FOR: RELANDSCAPING AT THE JUDICIAL COURTHOUSE

PLEASE SEE THE FOLLOWING ADDITIONS, CLARIFICATIONS AND/OR CHANGES:

JENKINS BRICK AND TILE COMPANY

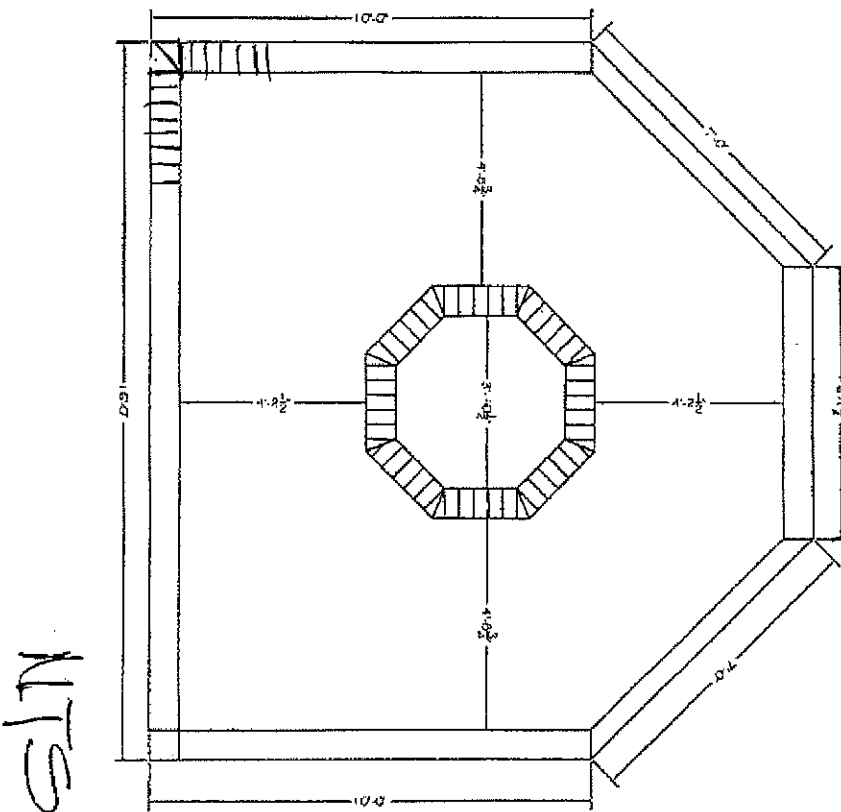
1. **Question:** Could we get a new detail on the brick installation in the path ways. The new paver that has been specified is a thicker paver than the original and there are several different ways that this can be installed.

2. **Question:** Is the "old mill" brick paver to be:
Set inside the concrete with or without grout lines?
Mortared in with or without grout lines?
Dry set with no grout lines?

Response: *2 1/4" Height, 4" Width, 8" Long*

Response: *Mortared in with grout lines.*
